**TOWN OF NEWBURGH
PLANNING BOARD
TECHNICAL REVIEW COMMENTS**

PROJECT NAME: HUDSON VALLEY CHRYSLER DODGE
PROJECT NO.: 15-01
PROJECT LOCATION: SECTION 97, BLOCK 2, LOT 11.2
ZONE: IB
REVIEW DATE: 13 MARCH 2015
MEETING DATE: 19 MARCH 2015
REPRESENTATIVE: JOHN MEYER CONSULTING

RE: Town Project #2015-01
JMC Project 14122
Hudson Valley Chrysler Dodge Jeep Ram
200 Auto Park Place
Town of Newburgh, NY

Site Plan Approval Re-Submission

TRUCK TURNING FIGURE

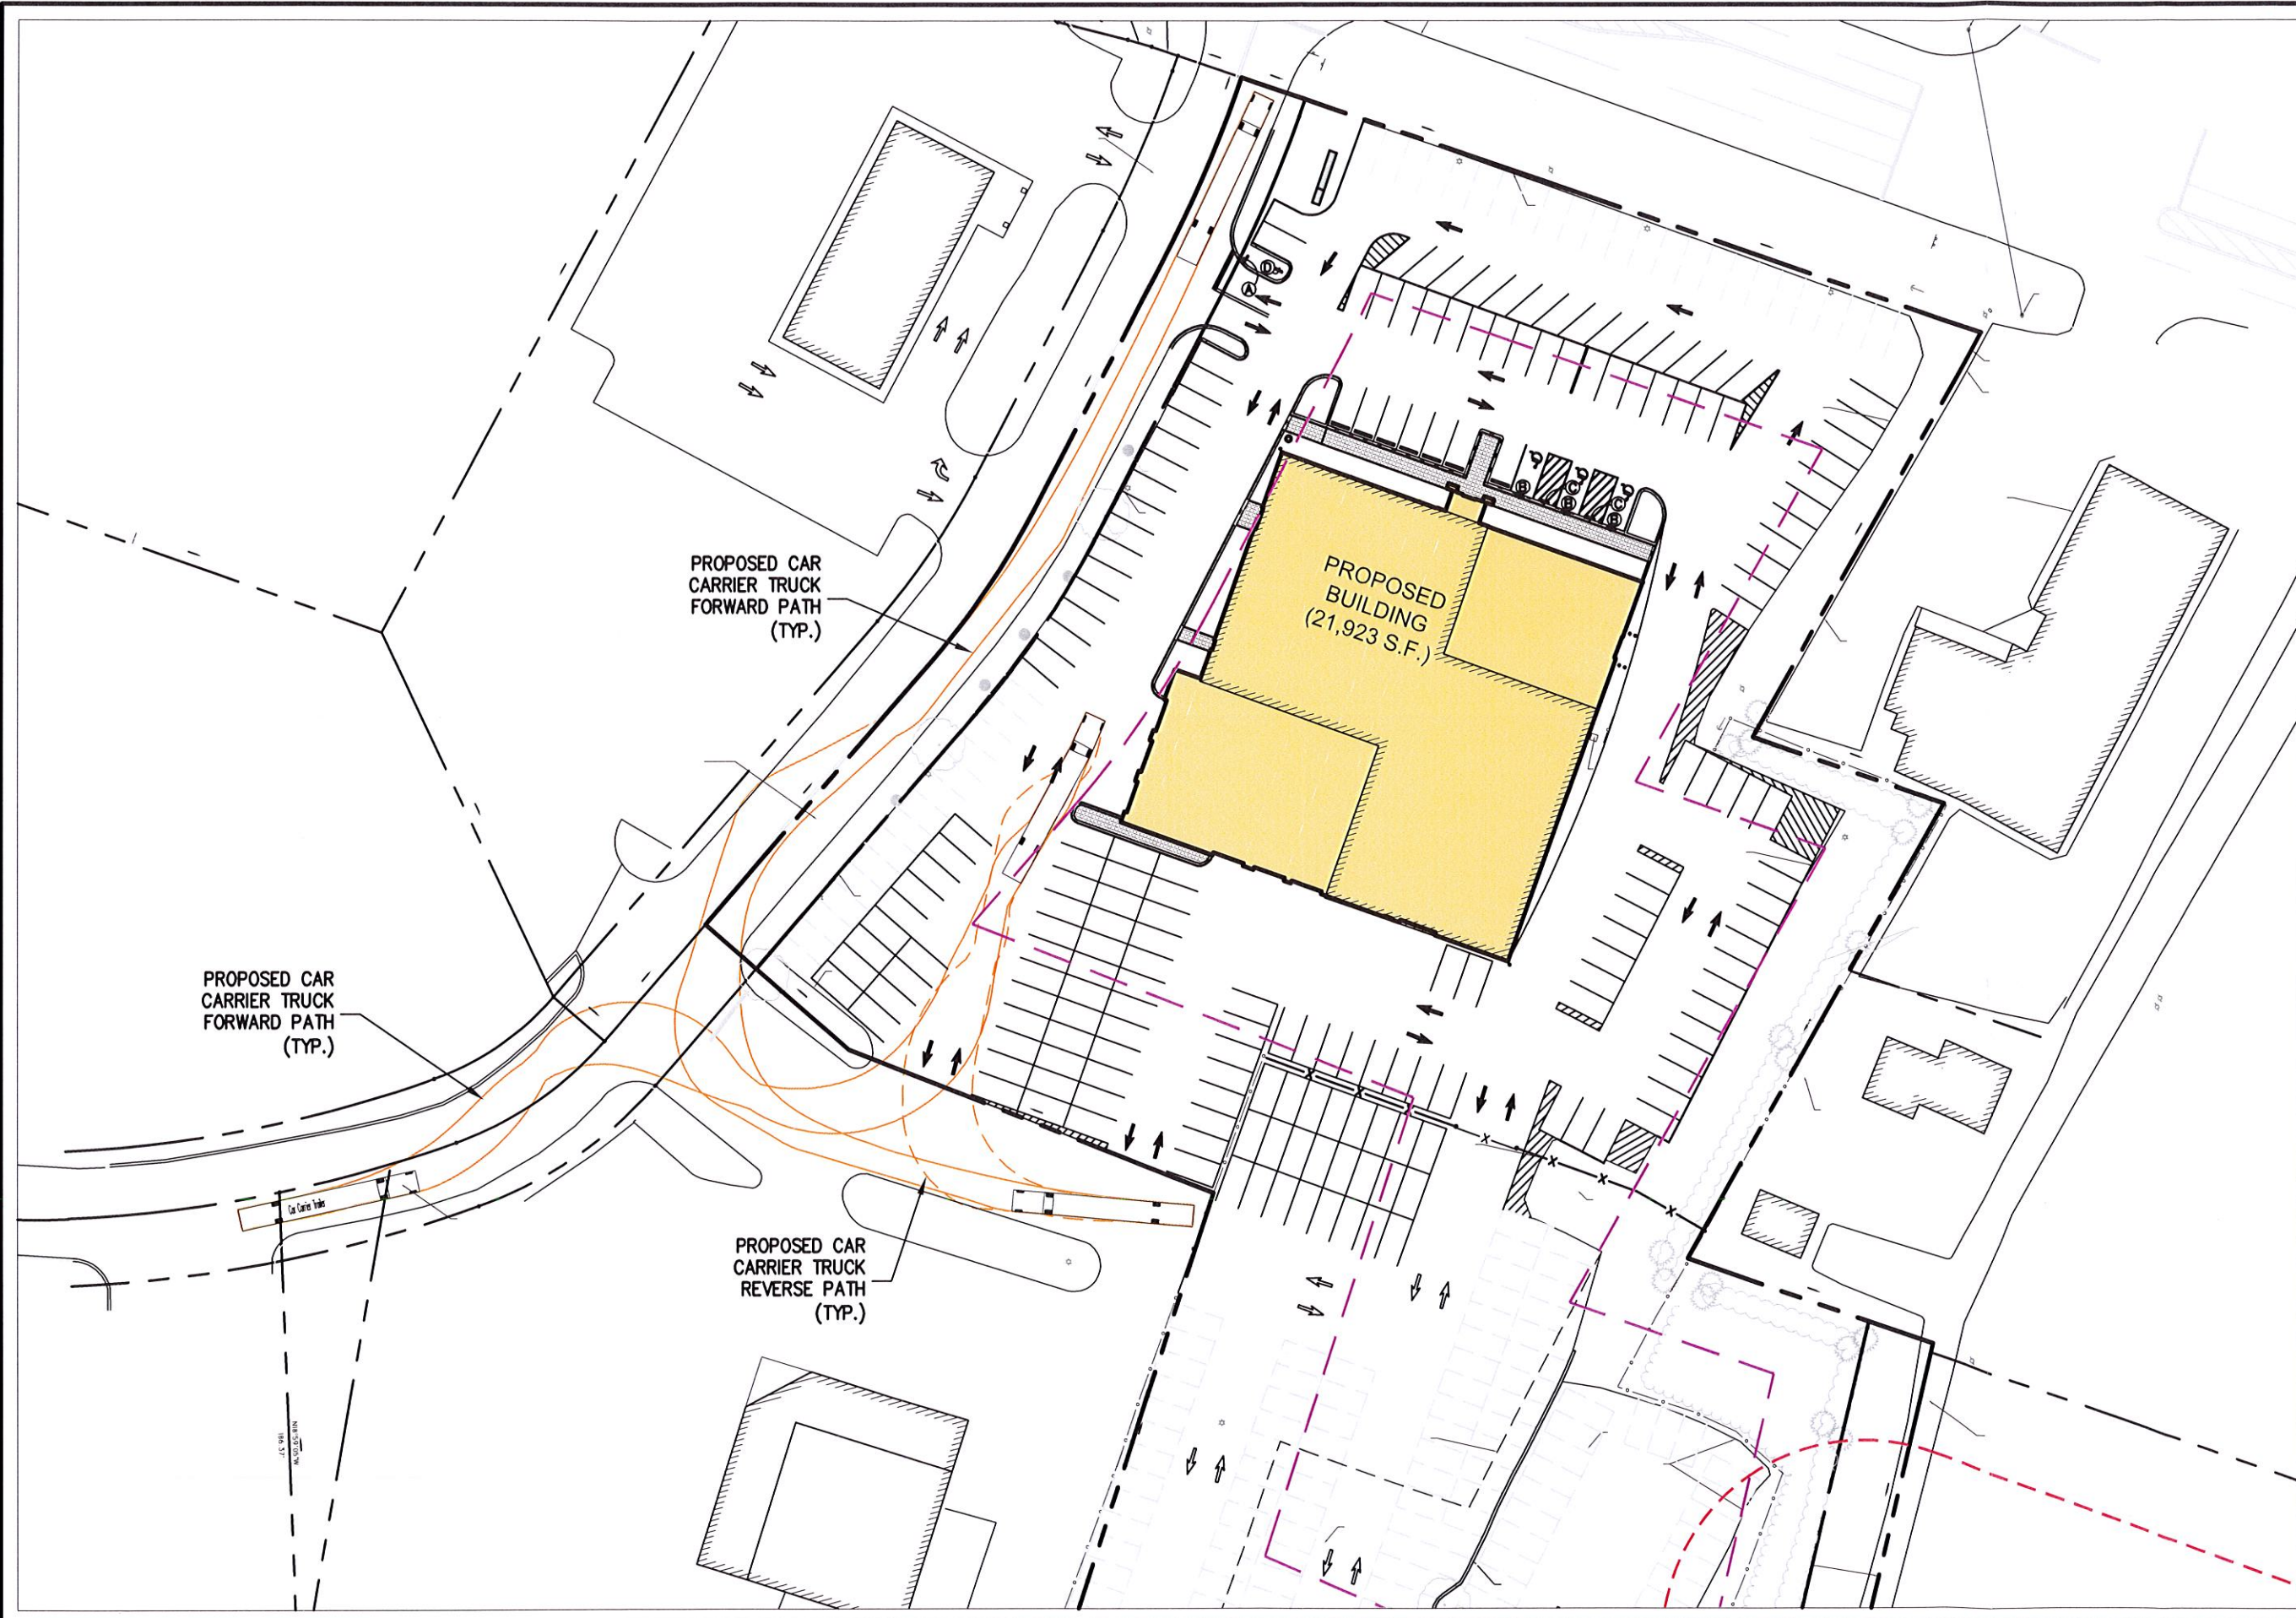
Delivery truck circulation should be shown.

We have prepared the enclosed delivery truck circulation Figure TT-1 "Truck Turning Figure", which depicts the vehicle delivery truck entering the shared driveway access then entering the property where it will park and unload. The truck would then back out of the shared driveway and then exit via Auto Park Place to NYS Route 17k.
